RE: Harmony Montessori School Renovation  
Portland, Oregon

Attached please find structural calculations for the seismic strengthening of the 2 story wood framed building located at 10541 SE Cherry Blossom Drive in Portland, Oregon, including new framing for a stair well. The seismic strengthening and new stair well are designed to meet the requirements of the 2010 Oregon Structural Specialty Code.

Attached below is our response to the plan review structural checksheet from the City of Portland.

1 SECOND FLOOR FRAMING PLAN  
1/8" = 1'-0"

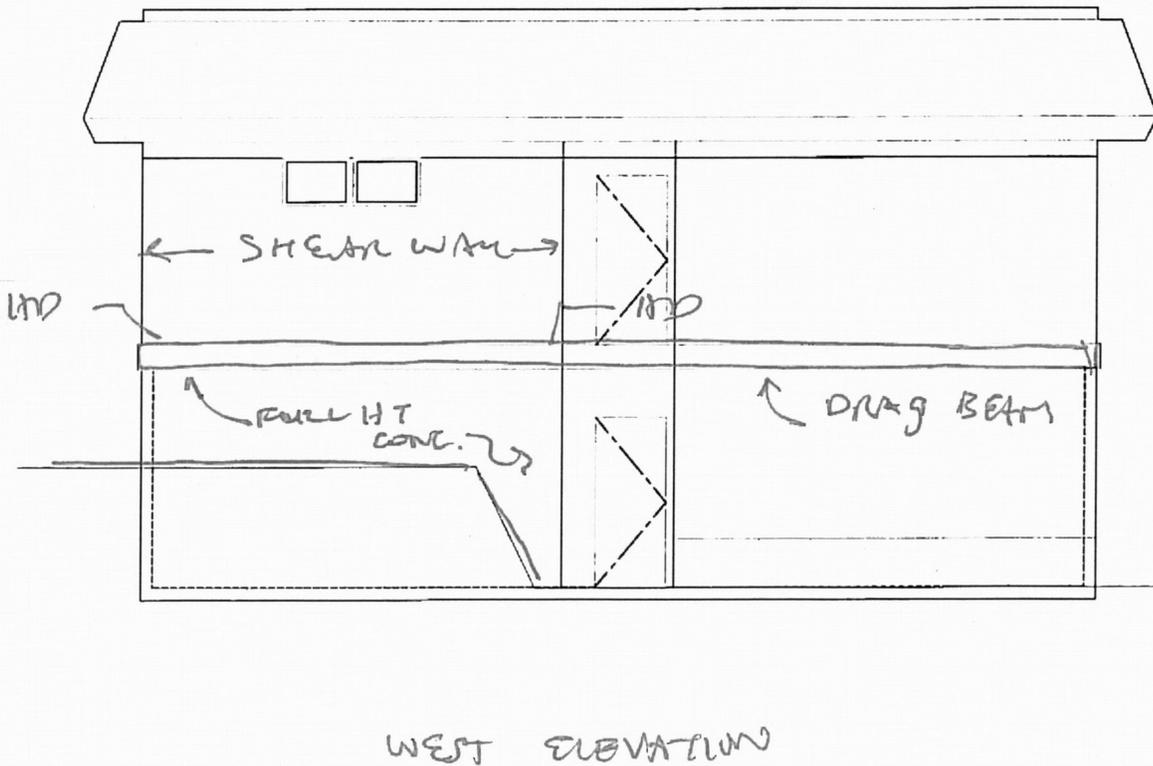
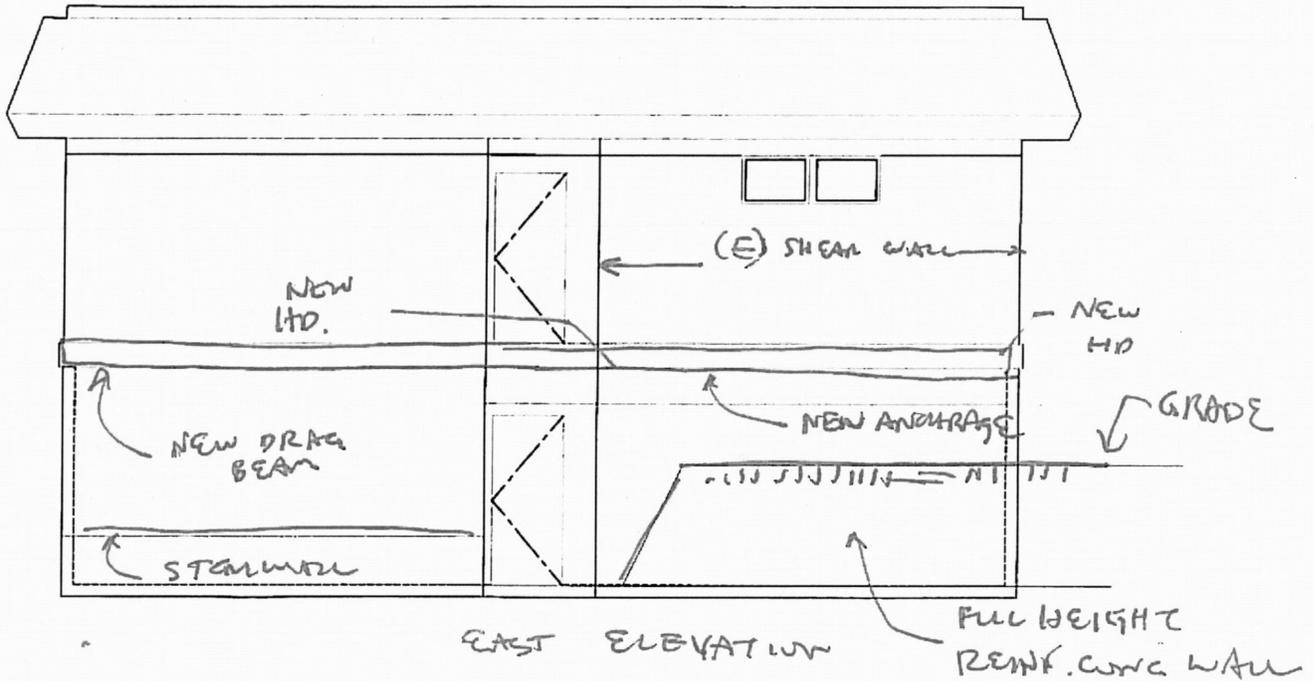
3.	1/S2.1 (2nd floor plan)		Detail 6/S7.1 cut on grid 10 between grids C and D does not appear to apply at this location. Please review and revise the detail reference as appropriate.  MBE Response: Plan changed to locate 6/S7.1 over beams.

4.	1/S2.1 (2nd floor plan)		The calculations (page 5) appear to indicate that new drag/collector work is intended for north-south loading at or near grids 1 and 10 at the 2nd floor. Please review and revise the drawings or clarify the intent as appropriate.  MBE Response: As noted on 2/S7.1, additional 2x12 added to existing 2x12 rim joist because a splice is assumed in the existing rim joist. 2/S7.1 notes that existing and new 2x12 draw beam are to be nailed with (2) 16d@16" o.c. page 6.
